**DOCUMENT 00 9113
ADDENDUM NO. 1
9/6/24**

SPECIFICATION NO. 24-11658-C

CITY OF BERKELEY

**CIVIC CENTER PARK UPPER PLAZA IMPROVEMENTS PROJECT
2135 MARTIN LUTHER KING JR WAY BERKELEY, CA 94705**

Figure 1: Section of layers for the suggested protective system in plan view.

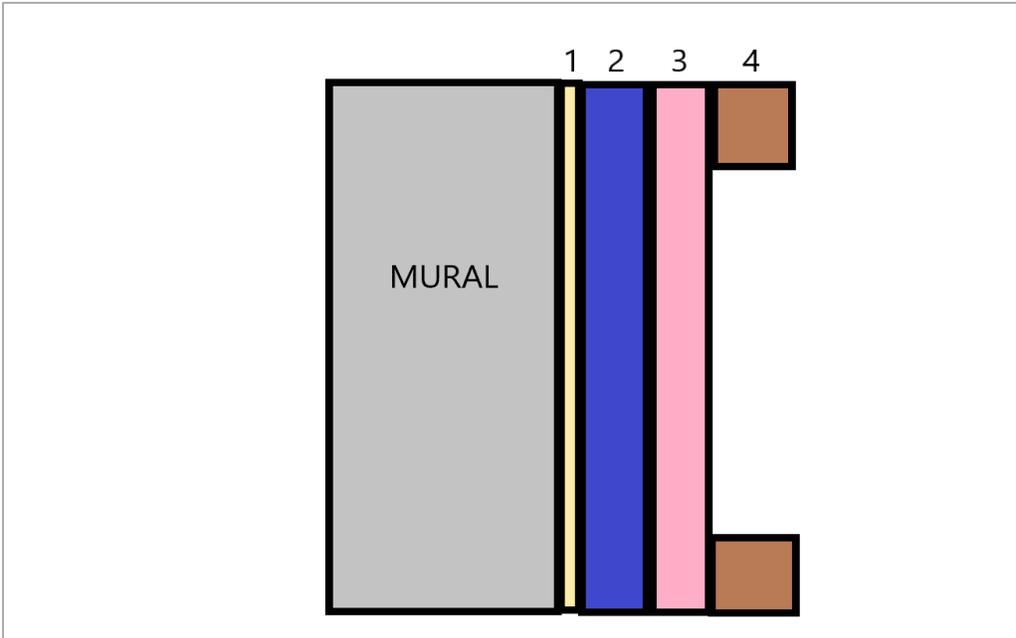
12. Are there any sketch details for the World Peace Wall protection?

1. Glassine paper
2. 1" ethafoam
3. ¼" plywood or masonite
4. Wood blocking/framing or clamps to hold layers in place – please note that the bottom 6-inches of the mural need to be exposed to lease sufficient space for repaving work.

Response: Yes, a sketch of the protection system is attached to this addendum.
